DSP-17004

STAFF REPORT

SUBJECT: Detailed Site Plan DSP-17004
Turkish American Community Center Day Care

SITE PLAN

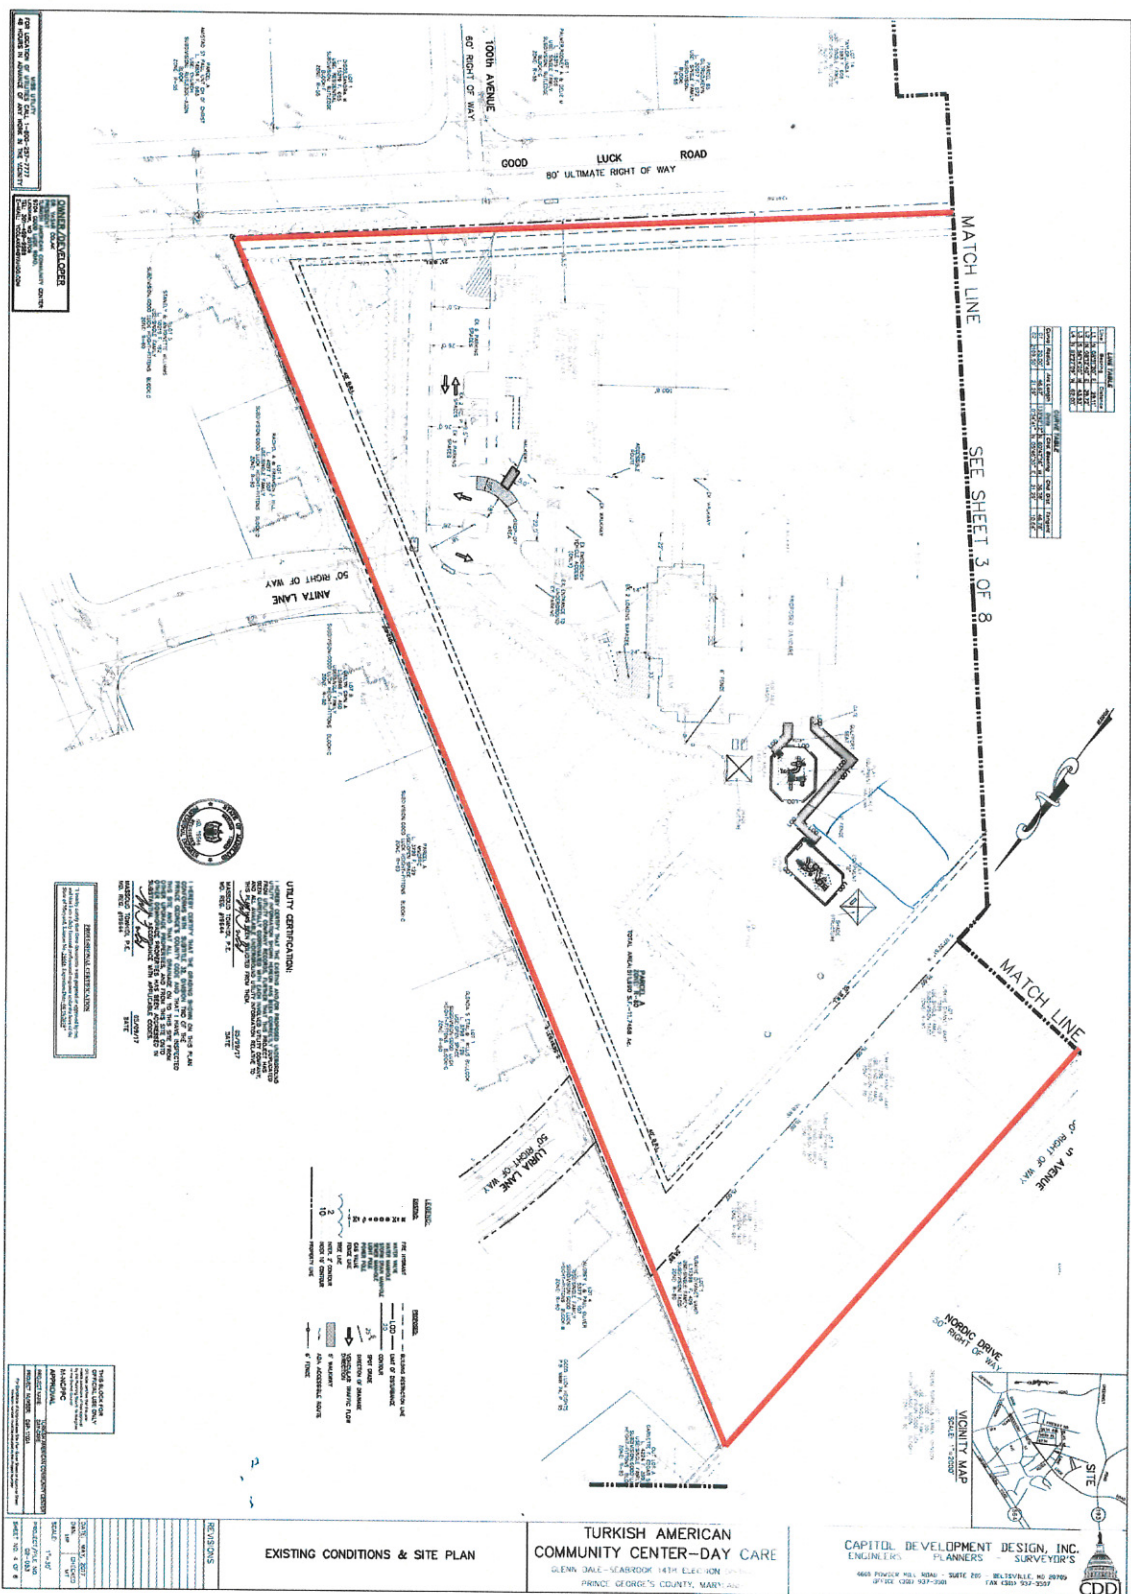
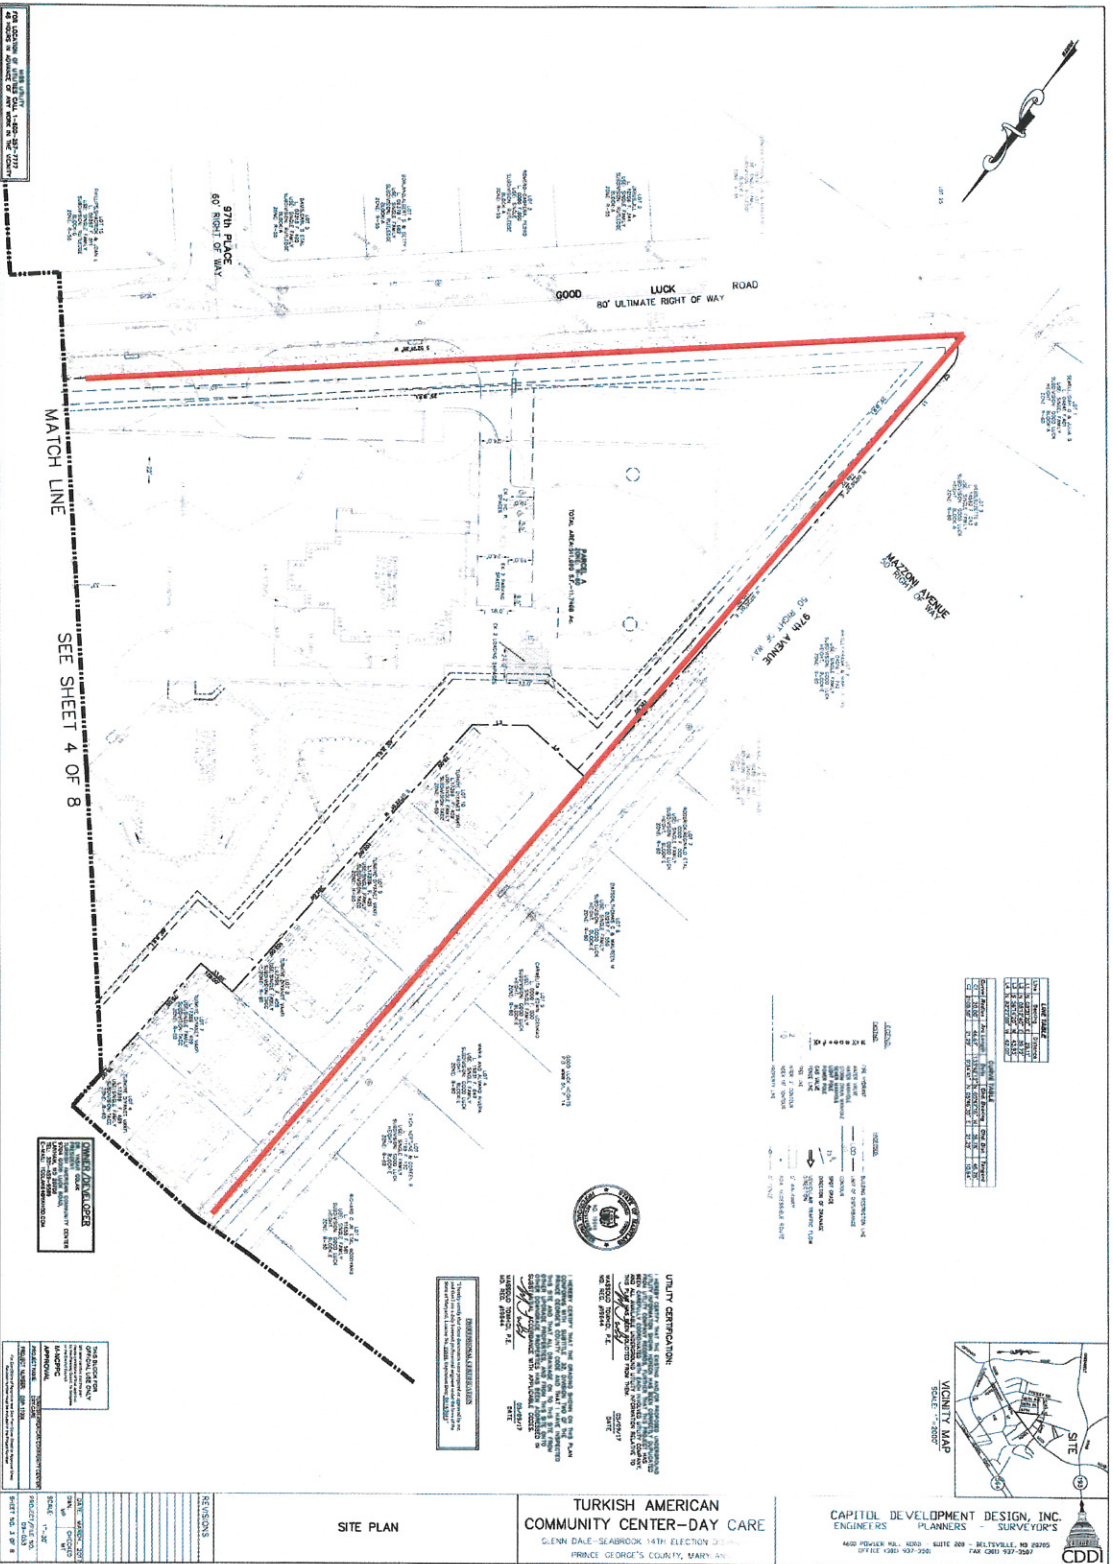
The site plan should be revised to correct Play Equipment “B” and a shade structure is located outside of the fenced-in play area. If these are part of the outdoor play area, they must be enclosed by a wall or fence at least four feet in height per Section 27-445.03(a)(1)(A)(ii) of the Zoning Ordinance. It also appears that the fenced-in play area does not scale 5,604 square feet as indicated on the site plan. This must be verified. The gross floor area devoted to the proposed day care center should be provided on the site plan.

Staff noted that the southernmost proposed concrete walkway is sharply angled resulting in the walkway being situated unnecessarily close against the edge of Reforestation Area 2 on the Type 2 tree conservation plan (TCP2). Staff would prefer this walkway to be redesigned so the walkway is less angled and more rounded, allowing for greater distance between the proposed walkway and Reforestation Area 2. The TCP2 should be revised to incorporate all proposed design elements associated with this DSP, expanding the limit of disturbance as necessary.

1. Prior to certification of this detailed site plan, the applicant shall make the following revisions to the plans and submit the following documentation:
 - a. Add a note to the site plan stating that the maximum day care center enrollment is limited to 120 children.
 - b. Add the gross floor area for the fellowship hall/day care center (11,827 square feet) to General Note 26.
 - c. Redesign the southernmost proposed concrete walkway, so the walkway is less angled and more rounded allowing for greater distance between the proposed walkway and Reforestation Area 2.
 - d. Label the 35-foot-wide building restriction line to match the record plat along the frontage of Cedar Lane.
 - e. Provide the site plan notes as follows:
